3
4 AN ORDINANCE approving Change Order
5 No. 13 in connection with the Water
6 Works Improvement Filtration Plant.

RE: City of Fort Wayne, IN
Water Works Improvements
Filtration Plant Additions
Contract 77-W-2

CHANGE ORDER NO: 13

Add — BULLETIN NO. 13
Addendum 3/27/81

WATERMAN MODEL C-20
 CANAL GATE

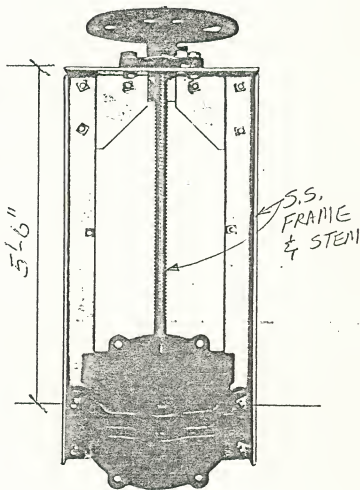
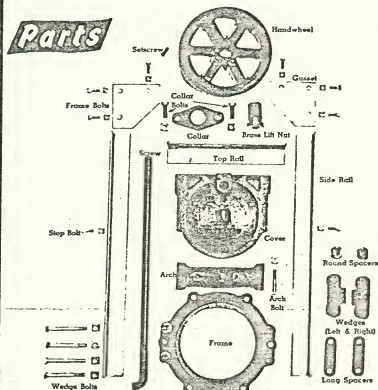
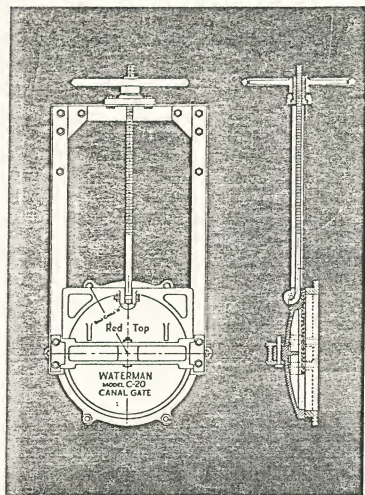
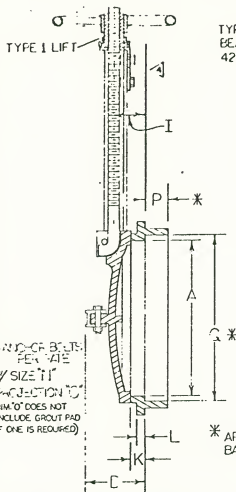
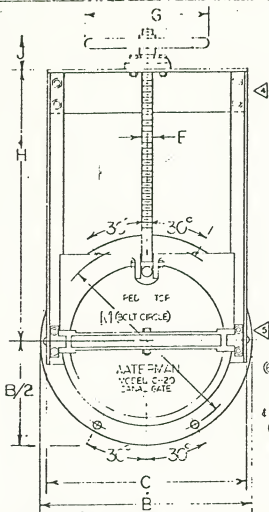
3. (Item c) Note in lieu of fiberglass slide gates we are quoting furnishing a Waterman type C-20 sluice gate (nut operated) center line of gate to top of frame 5'-6". We also will furnish five (5) fig. 1108 M & H floor boxes to be grouted in 10" round holes cored in floor. Please see enclosed details. The gates are to be operated by a T-wrench.

Light duty sluice gates are acceptable for use in the sludge sumps. Frames and stem to be stainless steel.

R.L.H. 4/6/81
 SKETCH M.H. #1
 BULL #13, ITEM G

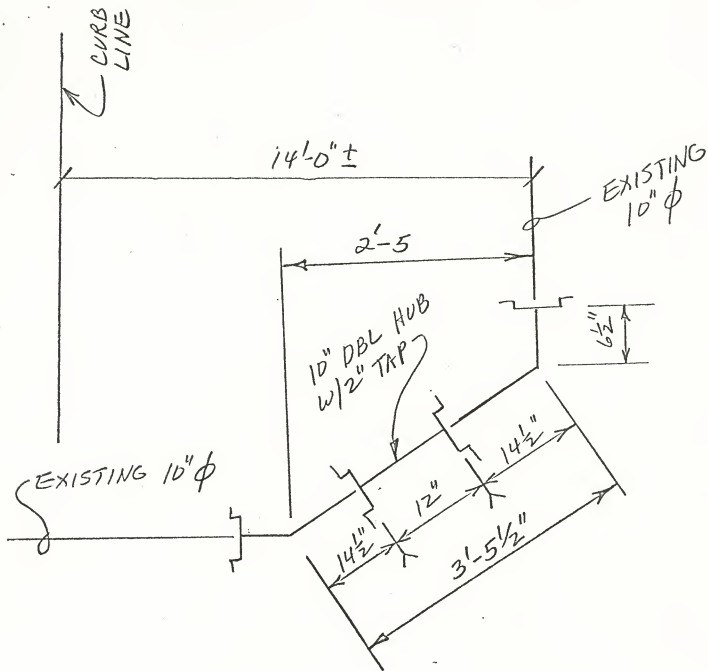
7. (Item g) This includes removal of upper portion of manhole and piping per sketch M.H. #1 dated April 6, 1981. We intend to leave in place bottom section of manhole, install piping and then backfill with sand to grade.

Please note we feel this change could be done without removing manhole at a reduced cost.

McNAMEE, PORTER AND SEELEY CONSULTING ENGINEERS ANN ARBOR, MICHIGAN		FORT WAYNE, INDIANA WATER WORKS IMPROVEMENTS FILTRATION PLANT ADDITIONS		CONTRACT 77-W-2
SCALE 1" = 50'	DATE 3-24-81	REVISIONS TO SLUDGE FORCE MAIN DEARBORN AT EDGEWATER		SHEET SM-4
DRAWN RJH	CHECKED JPO			OF

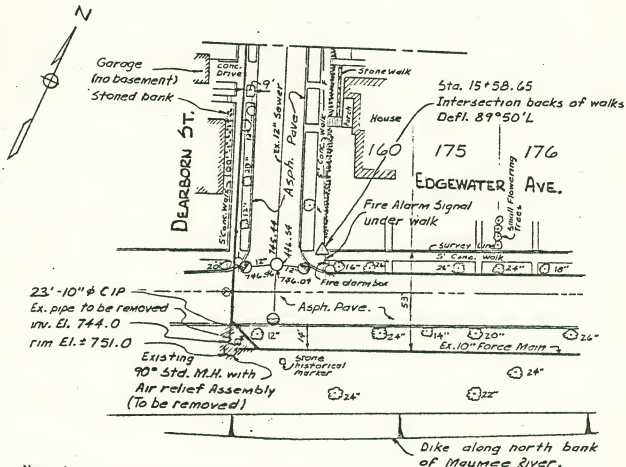
- g) Revise sludge pumping main at Dearborn and Edgewater Streets as shown on Supplemental Drawing SM-4 issued with this Bulletin. This item also includes surface restoration.

Contractor is to remove existing 90° standard M.H. and air relief assembly, cut into existing 10" force main and install new 45° bend, 23' (1')-10" CIP, 2" curb stop, 2" street washer and 45° bend. Furnish pipe restraint as specified under section 18. Street washer to be Clow F-4717, or equal. Provide valve box at curb stop. Restore surface to match existing conditions.

Ex. Force Main is approximately 7' deep.

We are not at this time recommending to proceed with changes at Dearborn and Edgewater Streets.
